## Technical Bulletin: Installation Action on ICM493-60A

Fig. 1

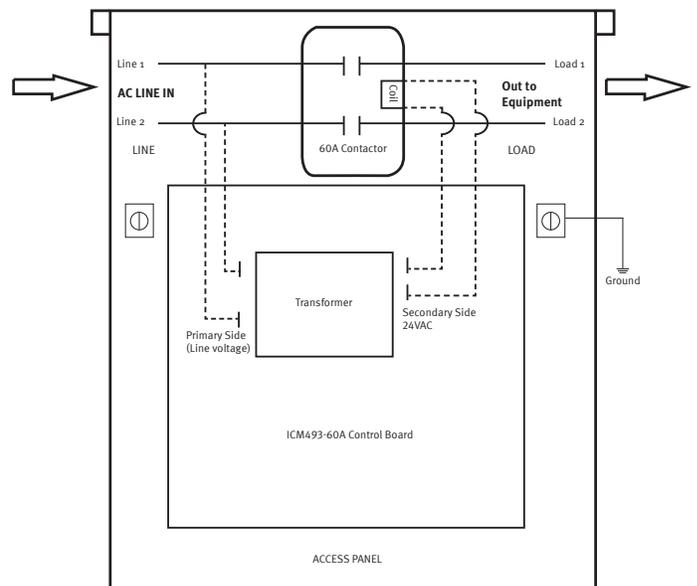
Regarding the ICM493-60A, the factory labeling for Line (L1/L2) and Load (T1/T2) connection is arbitrarily placed on the top of the contactor by the contactor manufacturer which could be opposite in orientation with respect to the ICM493-60A control board. The random contactor labeling could lead to confusion in wiring resulting in the inability of the ICM493-60A to power up. Since the contactor manufacturer 's label orientation cannot be guaranteed, ICM controls has created special labels on the ICM493-60A to clearly designate Line and Load connections to the contactor.

Effective February 2026, ICM Controls will clearly define both the Line and Load side of the ICM493-60A contactor with labels applied to the access door at the base of the contactor where the contactor is mounted to the door (see Fig. 1). In addition to this, ICM Controls will also update the wiring diagram and installation procedure in the install guide depicting the addition of these labels and the clarified wiring (Fig. 2).
